RE: SD-2021-001/ENG-2021-019/SEPA-2021-010

City of Mukilteo completed an initial review of your application and the supporting documents provided for a 7-lot subdivision located at 9110 53rd Avenue W, Mukilteo, Washington on October 8, 2021. Based on our review, the following revisions or additional information are necessary to complete our review of your project. If any of the items below are unclear to you, please do not hesitate to contact me right away so I can clarify them for you.

Figure 1 – Detention/Wet Vault “Bypass Basin” Areas as shown in yellow

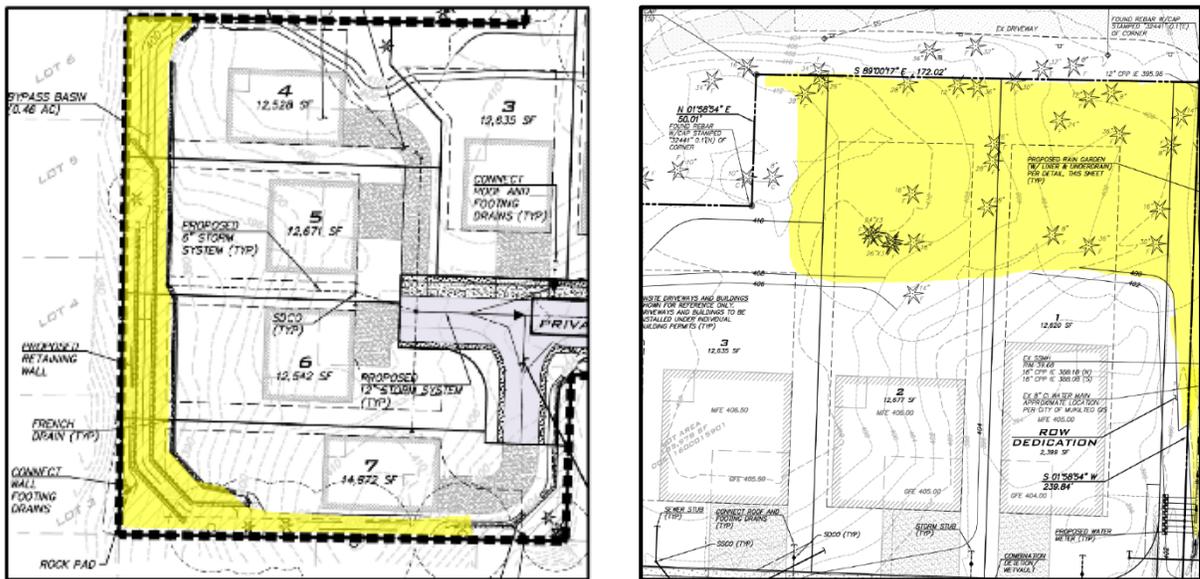
- a. 92nd Street SW *Public Comment No(s).*: (5)(6)(12)(15)
 - b. 53rd Ave drainage ditch to Smuggler’s Gulch Creek *Public Comment No(s).*: (1)(5)(6)(12)(15)
3. All drainage from “Bypass Basin” areas must be evaluated for impact on water quality and quantity. *Public Comment No(s).*: (2)(3)(4)(5)(6)(7)(8)(9)(10)(11)(12)(13)(14)(15)(16)(17)
- a. Drainage west and south of the French drain to neighboring properties.
 - b. Drainage from the northeast corner of the property.
 - i. This area is shown on the November submittal as a bypass that sheet flows to the City’s right-of-way. This stormwater must be accounted for within the private system. Please address stormwater from this area and update the Drainage Plan and Report. Evaluate capacity of storm systems as appropriate.
